Access Compliance Report

Public Rights-of-Way

(Curb Ramps)

Intersection ID: 45184	Main Street: HOLDEN_CT	Cross Street: TORRELLE_DR	Location: SW
ADA ID: 440C5F66FCE2	Ramp Type: BlendTrans1	Initial Pass/Fail: Fail	Overall Compliance: No
Severity Score: 25			
Codes/Mitigation Info/Possible Solution		Field Measurements/Component Compliance

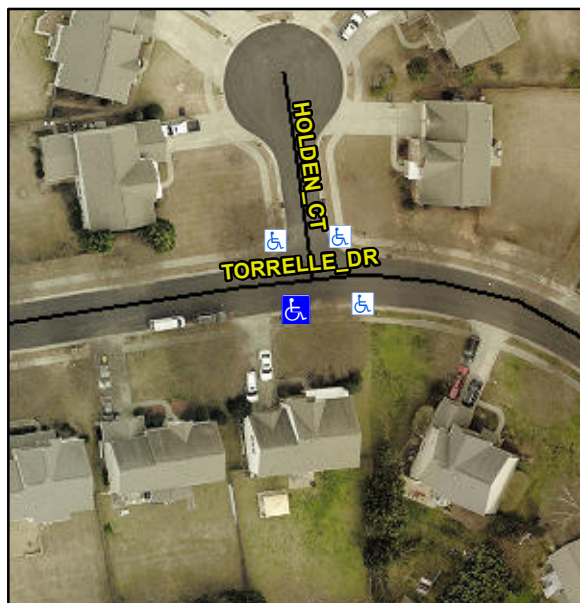
Not Found, R304.5.3

Compliance	Description	Data	Compliance	Description	Data
N/A	Ramp Length (in)	47.0	Yes	BlendTrans Slope (%)	4.0
Yes	Ramp Width (in)	58.0	No	BlendTrans XSlope (%)	7.1
N/A	Flare Type LT	N/A	N/A	Flare Type RT	N/A
N/A	Flare Slope LT (%)	N/A	N/A	Flare Slope RT (%)	N/A
N/A	Flare Traversable LT?	N/A	N/A	Flare Traversable RT?	N/A
N/A	Landing Length (in)	N/A	N/A	DWS Provided?	N/A
N/A	Landing Width (in)	N/A	N/A	DWS Contrast?	N/A
N/A	Landing Slope (%)	N/A	N/A	DWS Length (in)	N/A
N/A	Landing X Slope (%)	N/A	N/A	DWS Full Width?	N/A
N/A	Landing Curb? (Y/N)	N/A	N/A	DWS Offset (in)	N/A
N/A	Shared Landing?	N/A			
N/A	Gutter Ponding?	N/A	N/A	Gutter Slope (%)	N/A
N/A	Gutter Lip Ht (in)	N/A	N/A	Gutter X Slope (%)	N/A
N/A	Painted X Walk1?	No	N/A	Painted X Walk2?	N/A
	X Walk 1 Direction	To N		X Walk 2 Direction	N/A
	X Walk 1 Width (in)	N/A		X Walk 2 Width (in)	N/A
	X Walk 1 Slope (%)	0.9		X Walk 2 Slope (%)	N/A
	X Walk 1 X Slope (%)	1.3		X Walk 2 X Slope (%)	N/A

N/A	Ramp inside XWalk1?	N/A	N/A	Ramp inside XWalk2?	N/A
	Road Slope (%)	1.3		Clear Space?	N/A
	Road X Slope (%)	0.9	N/A	Clear Space to XWalk (in)	N/A
N/A	Any Obstructions?	N/A	N/A	Storm Grate/Utility Hazard?	N/A
	Obstruction Type			Storm Grate/Utility Type	
		N/A			N/A
			Yes	Surface Condition? (G/P)	Good
			No	Curb Slope (%)	13.4

Remove & Replace Curb Ramp With Two New Directional Ramps or Equivalent.
